Application by Equinor for an Order Granting Development Consent for the Sheringham and Dudgeon Extension Projects.

Examination Timetable – Deadline 3

Examining Authority's Written Questions 2

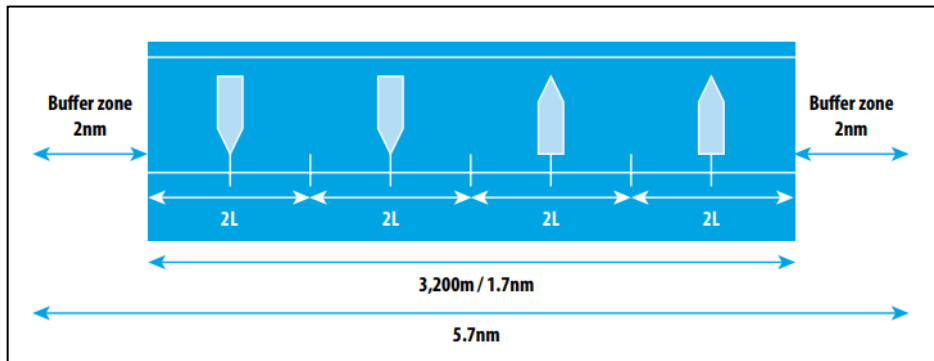
The Nautical Institute and The World Ocean Council published guidance on shipping lane widths for two-way traffic in 2013 titled "*The Shipping Industry and Marine Spatial Planning*". This is based on adequate sea room to allow four vessels to safely pass each other:

Assuming 195m LOA, the corridor would be $8 \times 195\text{m} + 4\text{NM} = 4.84\text{NM}$. Using the safety buffer distance from the PIANC guidance the corridor width should be $8 \times 195\text{m} + 2.4\text{NM} = 3.24\text{NM}$ or 6km.

Although the proposed extensions appear to comply with the minimum clearance derived from the guidance (using 195m LOA), the MCA believes that due to the particular circumstances of the area concerned, wider safety parameters should be adopted. The 195m LOA measurement used in the above calculations was taken from a week of AIS data in August 2021. The applicant collected two 14-day traffic surveys in summer and winter and 12 months of AIS data from 2019, and while the NRA does not provide any details on LOA, the 195m figure is likely to be an underestimation. The guidance assumes a central division for vessels heading in opposite directions, in this case north and south. The absence of a sea lane or any traffic separation scheme initiatives in this area is of relevance to our concerns. Traffic can, and does, transit the area in a north and south direction without any obligation to keep to one side or the other.
